Proposal for amendment to ECE/TRANS/WP.29/GRSP/2013/23 (Draft 01 series of amendments (Phase 2 of the Regulation))

Note: The modifications to ECE/TRANS/WP.29/GRSP/2013/23 are marked in bold and strikethrough characters.

In Annex 6 Appendix 1, Replace Figure 1 by the following:

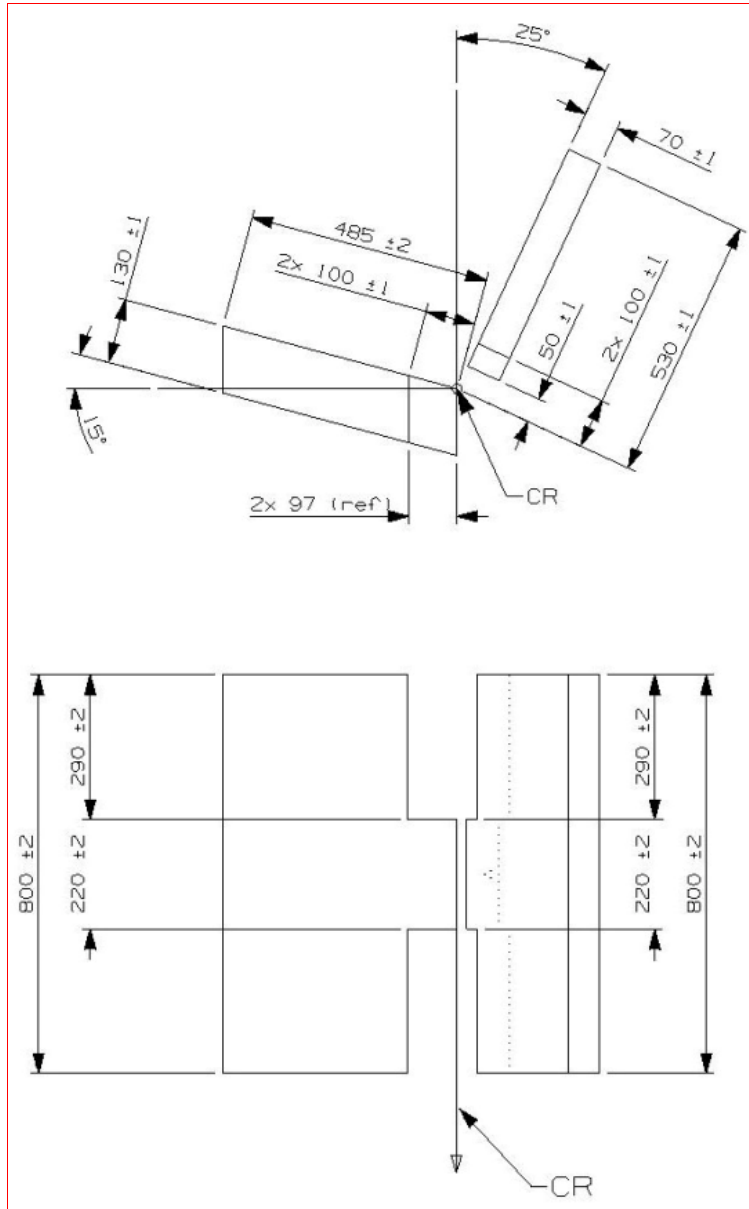
Figure 1 of Annex 6 Appendix 1 includes a gap between the backrest and the seating cushions and a reference to the Cr point.
